APPLICATION NO.	FILING DATE	FIRST NAMED INVENTOR	ATTORNEY DOCKET NO.	CONFIRMATION NO.
10/663,995	09/17/2003	Soon Jo Lee	9988.059.00-US	1979
30827	7590	12/29/2004	EXAMINER	
MCKENNA LONG & ALDRIDGE LLP 1900 K STREET, NW WASHINGTON, DC 20006			GRAVINI, STEPHEN MICHAEL	
			ART UNIT	PAPER NUMBER
			3749

Office Action Summary

10/663,995

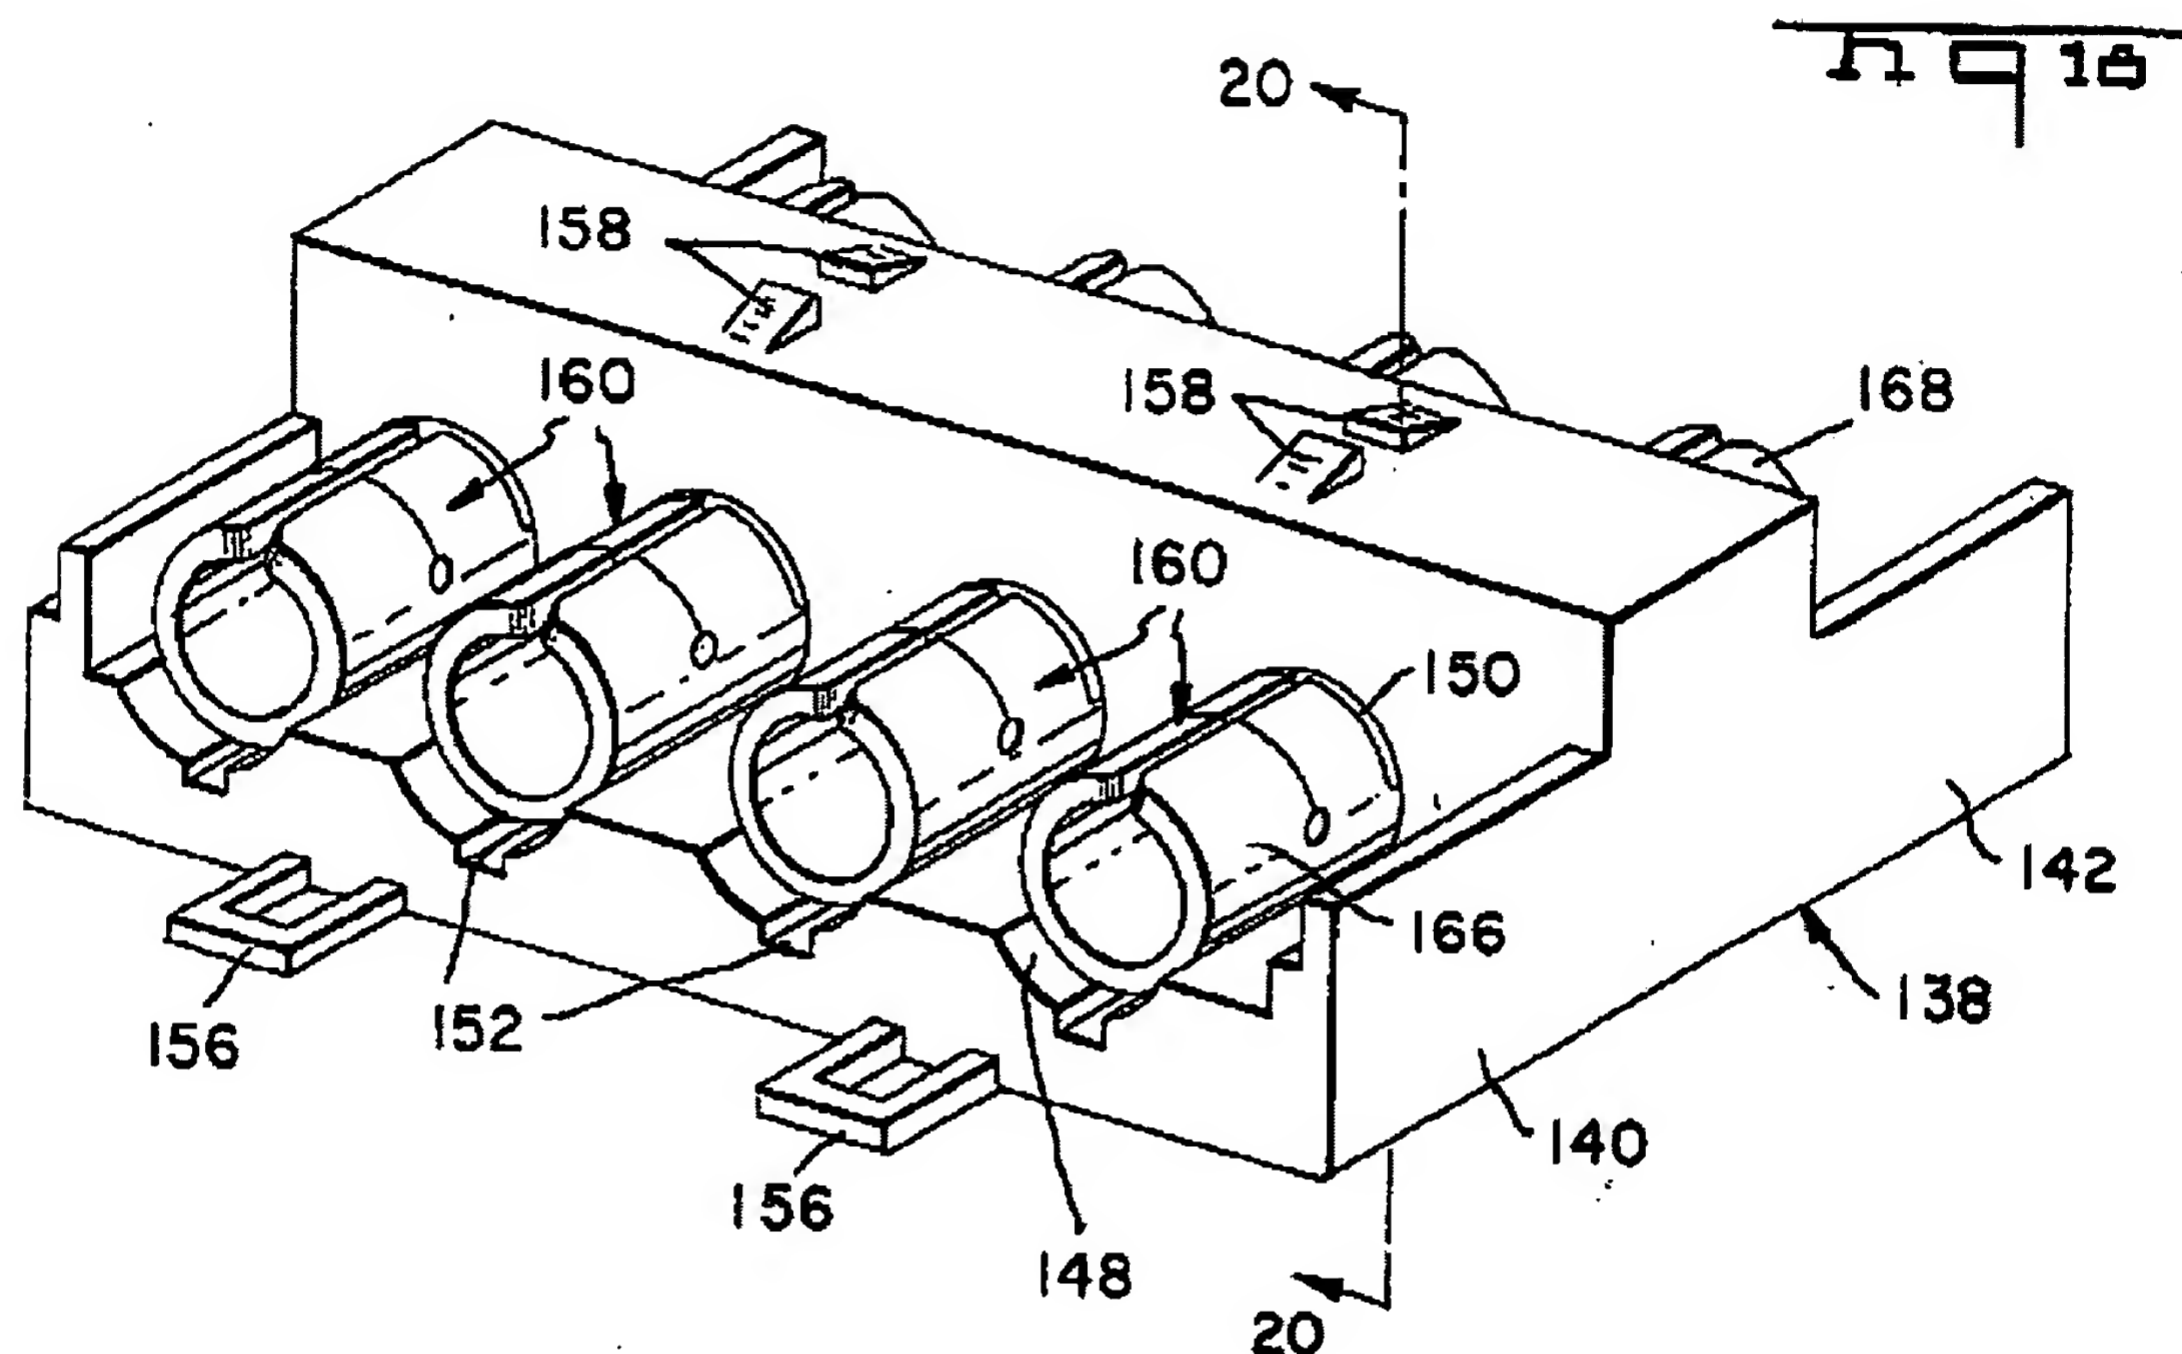
a terminal block **138** disposed within the laundry dryer control panel, the terminal block having a lower part **140** and an upper part **142**;

a wall extending from the terminal block lower part and the terminal block upper part (please see figure **18** reproduced below wherein the raised portion surrounding reference character **166** and above reference character **142** is considered to anticipate the claimed wall because both extend from a terminal upper and lower part respectively);

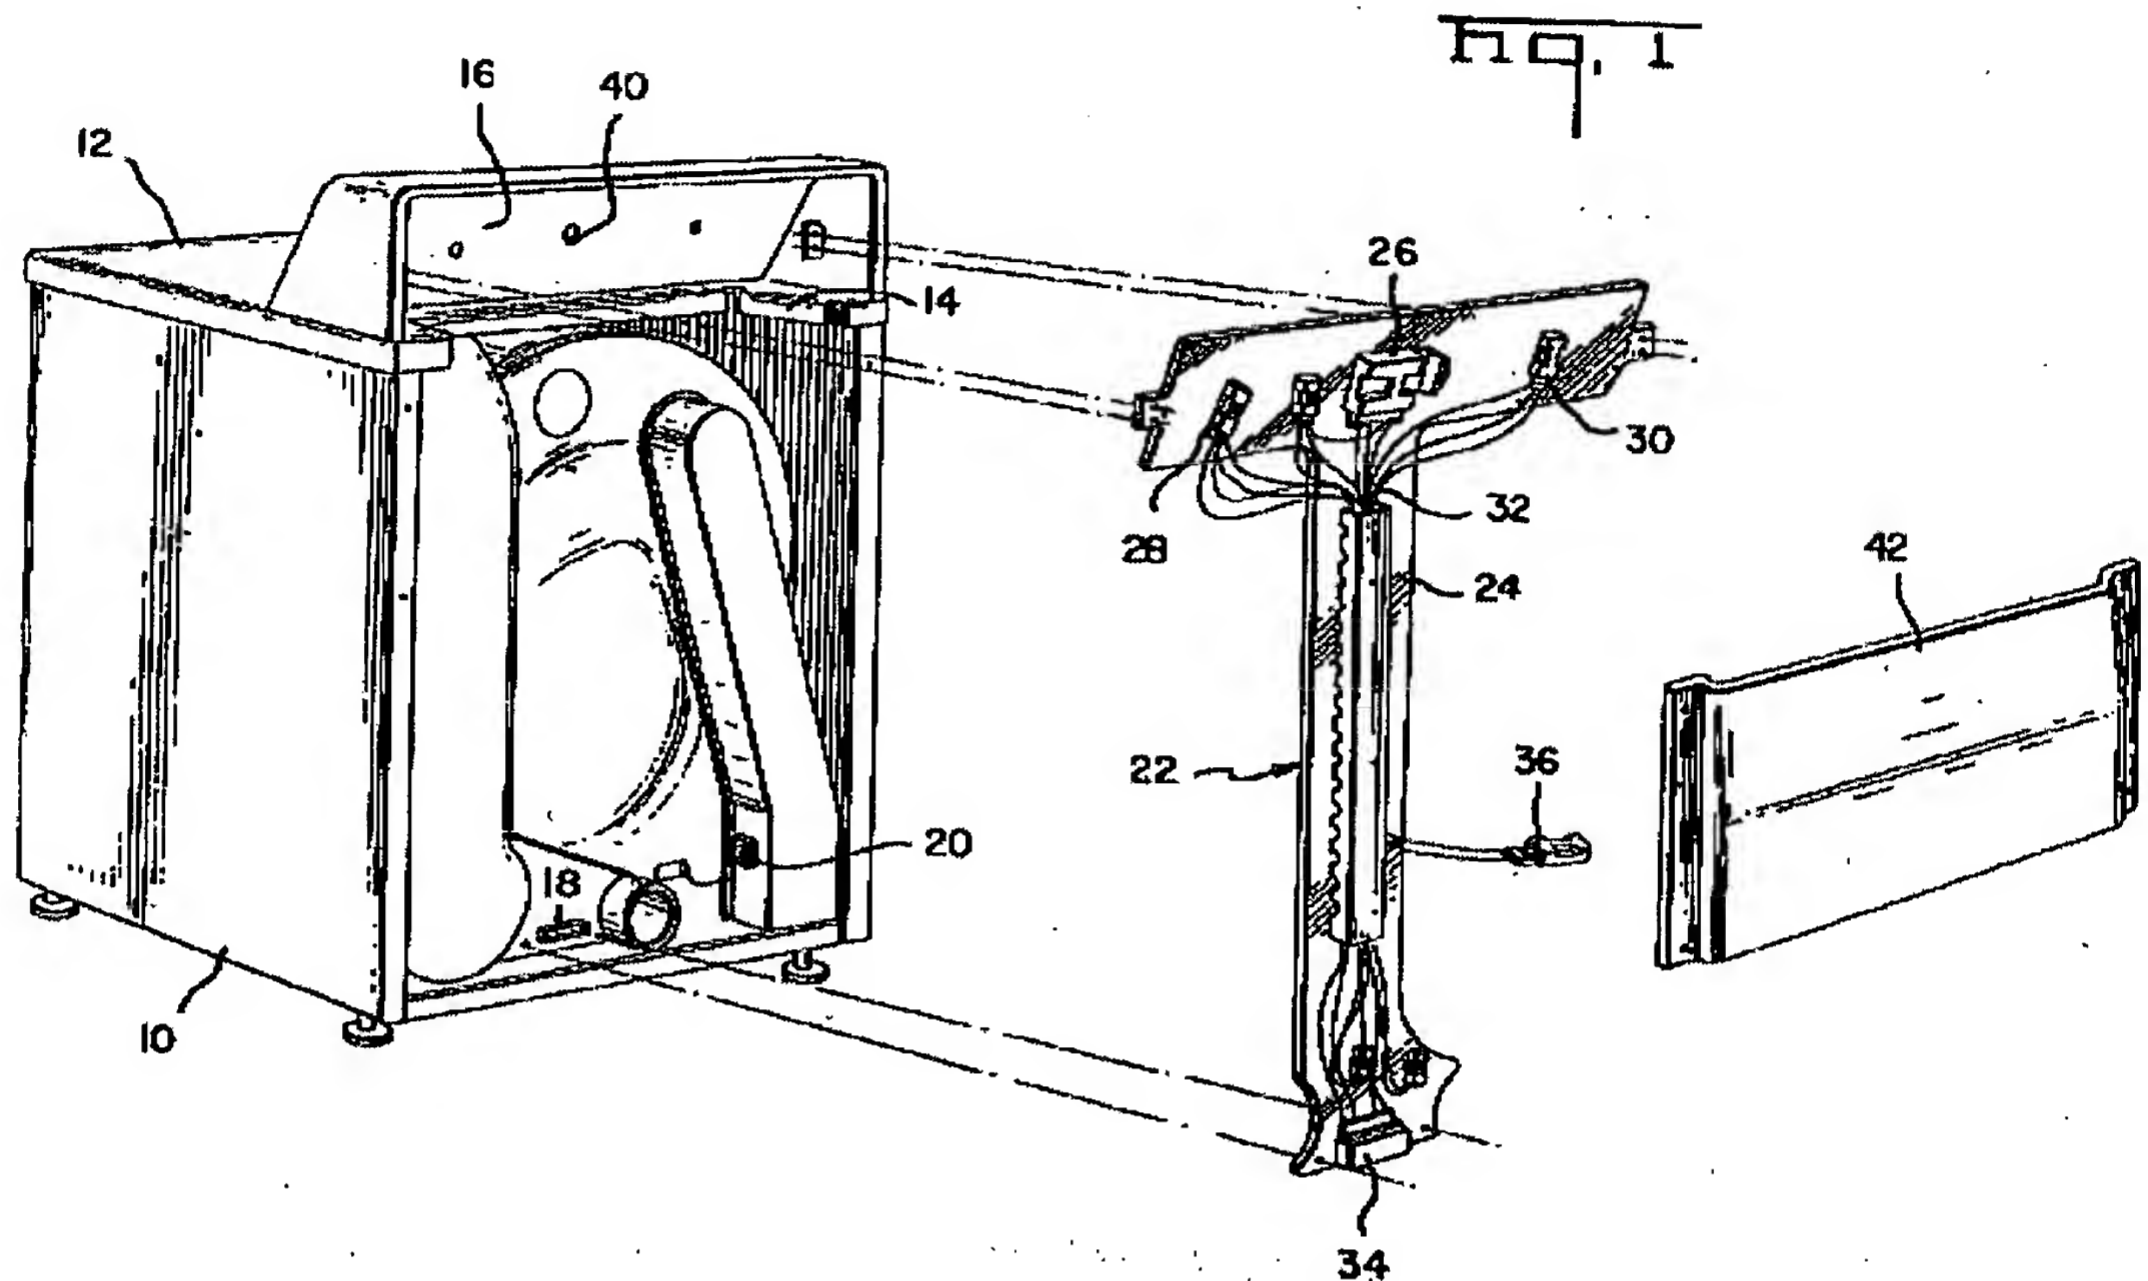
- base **314** forming a floor;
- a front cabinet **211** forming a front portion of the clothes dryer;
- a side cabinet **218** forming a side portion of the clothes dryer;
- a top cover **216** provided on a top surface of the front cabinet, the side cabinet and the back cover;
- a control panel **217** provided on a rear portion of the top cover. McCormick is considered to disclose the claimed invention except for the claimed back cover forming a back side of the clothes dryer, terminal block provided on an inside of the control panel, a wall for shielding an exposed part of core wire extending from an upper front portion and lower front portion of the terminal block including a single body terminal block formation. Hopkins, another structure for a clothes dryer, is considered to disclose a back cover **42** in figure 1 (shown below),

a wall for shielding an exposed part of core wire extending from an upper front portion, and lower front portion of the terminal block including a single body terminal block formation as discussed in the anticipatory rejection above. It would have been obvious to one skilled in the art to combine the teachings of McCormick with the back cover, wall for shielding an exposed part of core wire extending from an upper front portion, and lower front portion of the terminal block including a single body terminal block formation, considered disclosed in Hopkins, for the purpose of producing an improved completely hermaphroditic electrical contact terminal having an insulation displacing portion and an intermating portion adapted to engage a relatively wide range of related contacts.
